# Section 1007.6 Areas of Refuge

**Figure 10-26**

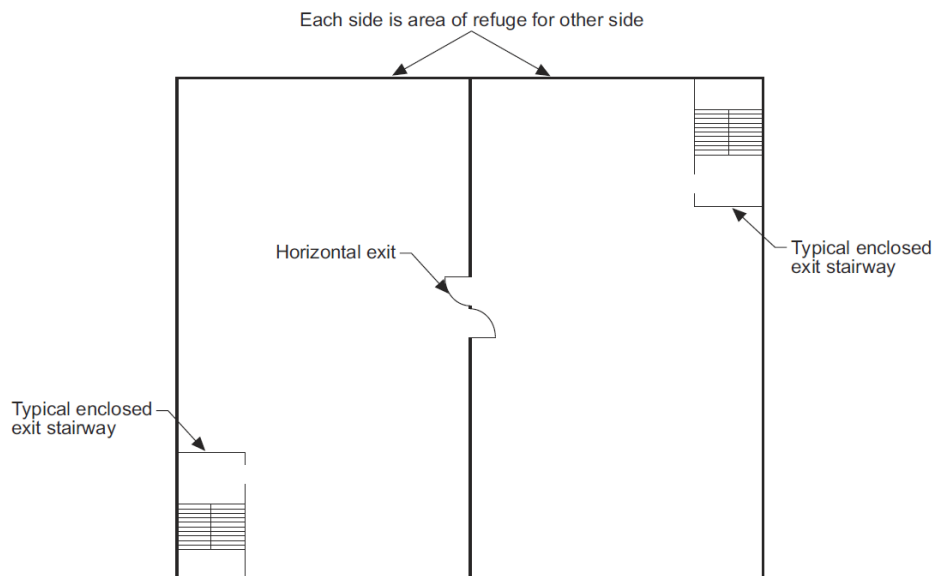
**Q:** When two accessible means of egress are required from a floor, can providing a single horizontal exit serve to establish both required accessible means of egress, with one “area of refuge” provided on each side of the horizontal exit? The concept is demonstrated by Figure 10-26. We have also understood that each accessible portion of a building must have two accessible means of egress available to it. Therefore, must there be an additional area of refuge next to the stairway provided on each side of the horizontal exit, such that each accessible space (each side of the horizontal exit) is provided with two accessible exits?

**A:** When a horizontal exit is incorporated into a building, the intent of the code is that the portion of the building occurring on one side of the horizontal exit “wall” serves as a refuge area for the other side of the wall that is separated by the horizontal exit. Thus Figure 10-26 accurately reflects the requirement, and an additional area of refuge is not needed at each stairway. [10-26]
